Title		California Institute of Technology LIGO Project		LIGO	
Size: B	DCC Number: D1001974	Revision: v6	Engineer: Mohana/R. Abbott	Date: 9/16/2014	Time: 9:30:11 AM
File: C:\Rich's Files\Mycadfiles\ISCaLIGO Quadpd amp\D1001974-v5\QPD.SchDoc					
Sheet 1 of 3

Title		* California Institute of Technology		LIGO
<b>Transimpedance and Whitening Amplifier</b>		LIGO Project		
Size: A	DCC Number: D1001974	Revision: v6	Engineer: Mohana/R. Abbott	Date: 9/16/2014
File: C:\Rich's Files\Mycadfiles\ISC\CaLIGO Quadpd amp\D1001974-v5\Main Amp.SchDoc				Time: 9:30:12 AM
				Sheet 2 of 3

D1001974-v5  
ISC QPD Transimpedance Amp

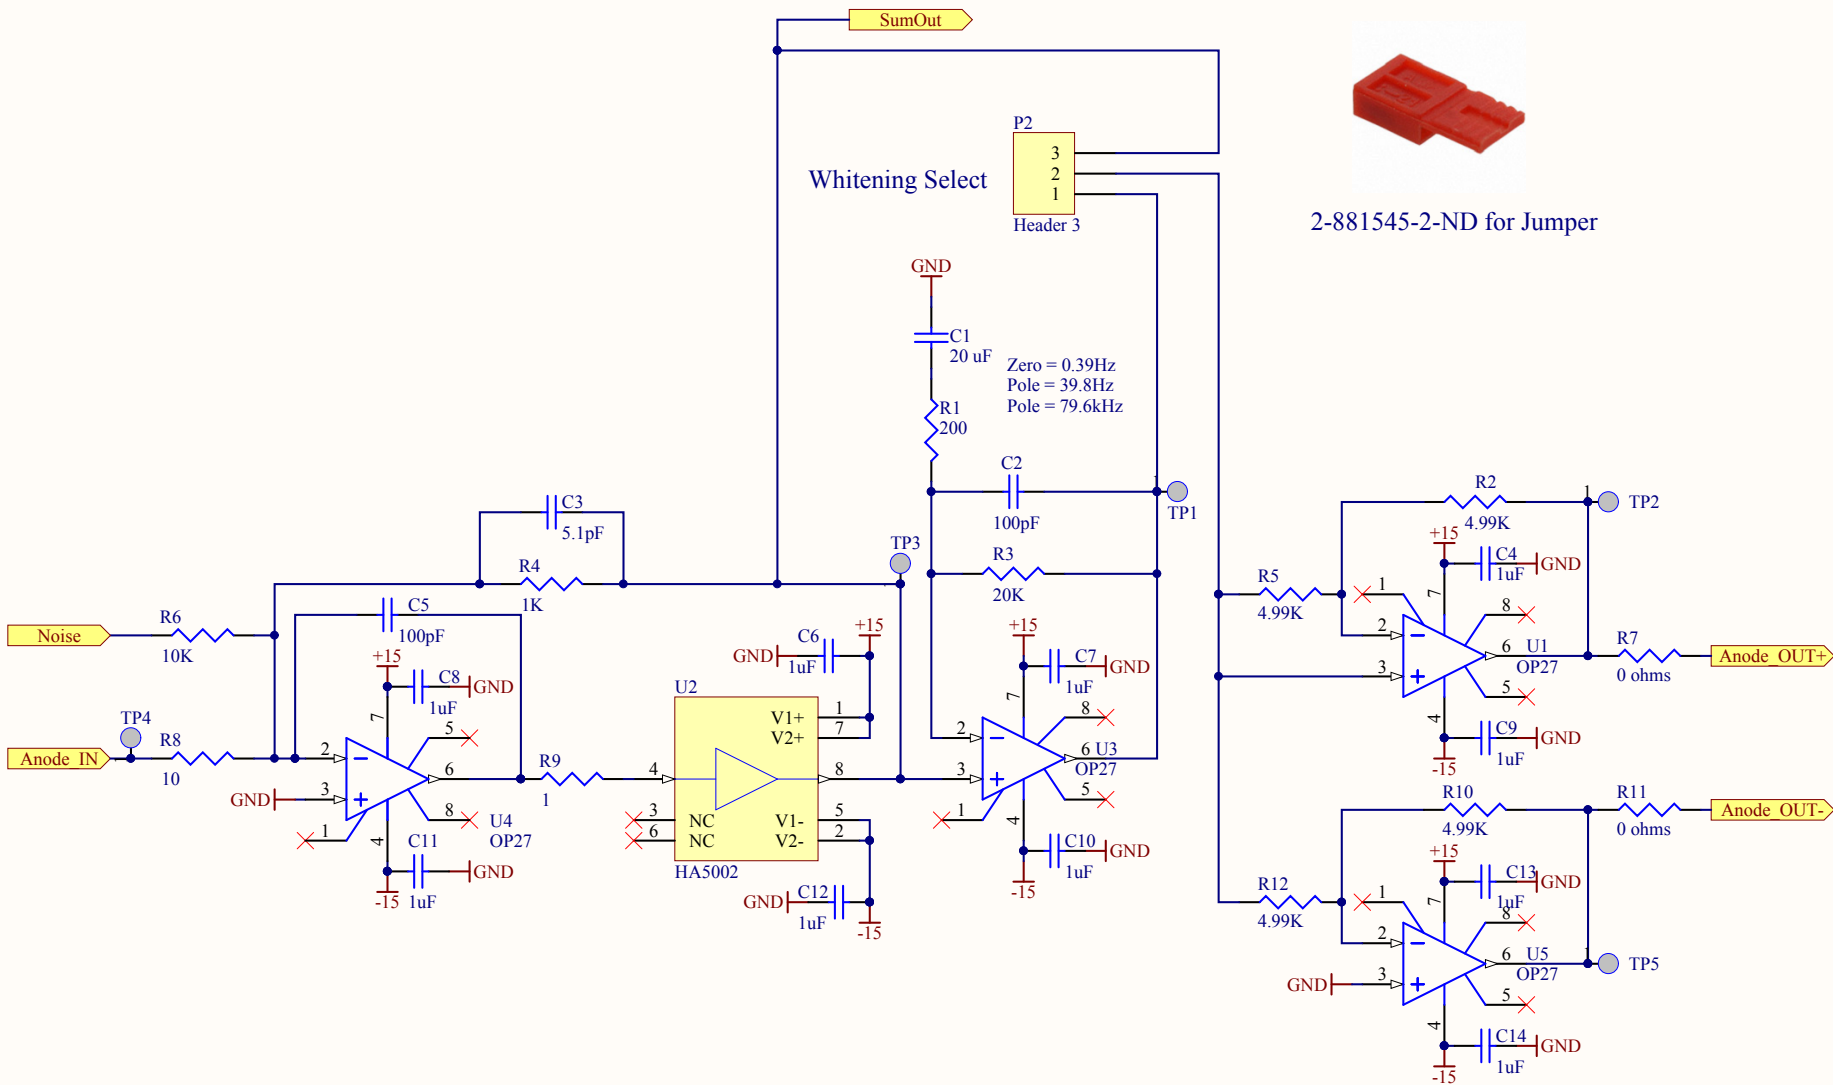
Change History  
 Version 1 - Initial Release  
 Version 2 notes:  
 (1). R18 = 240, R17 = 336 for 3V DC on LM317. A formal decision on the bias voltage  
 (2). DS1, DS2 are dual type LEDs for convenience and lower parts count  
 (3). Add R15 = 0 ohms resistor in series with the noise cancellation output. This is a backup incase we don't like the noise amp anymore  
 (4). JP1 is added to the input of the Noise Cancellation Amp. This is for testing purposes  
 (5). J2, J3 DB9 connectors shells are grounded to improve cable shielding  
 Change History - V3 Schematic Only and the PCB Boards are in V2

Version 3 notes:  
 (1). Capacitor C15 is removed  
 (2). Resistor R15 attributes have been changed correctly to 0 ohms.  
 (3). PCB Board physical layout is the board generated in version 2 still

Version 4 (R. Abbott)  
 1. Added jumper (P1) to board to disconnect the noise amp  
 2. Added explanatory text to PCB in case future boards are ordered  
 3. Changed all front end transimpedance amplifiers from AD8675 to OP-27 due to fragile input structure on AD8675

Version 5 (R. Abbott) PCB Revision is now Version 5 too  
 1. Added sum output via BNC on rear of board  
 2. Added jumpers to allow choice of whitened or unwhitened outputs for each channel  
 3. Upgraded bias regulator due to part obsolescence  
 4. Cleaned and groomed the BOM plus the PCB layout

Version 6 (R. Abbott)  
 1. Changed value of R23 from 20k to 1.24k to avoid saturation if all four quadrants are at 10VDC. Version 5 PCB is still current
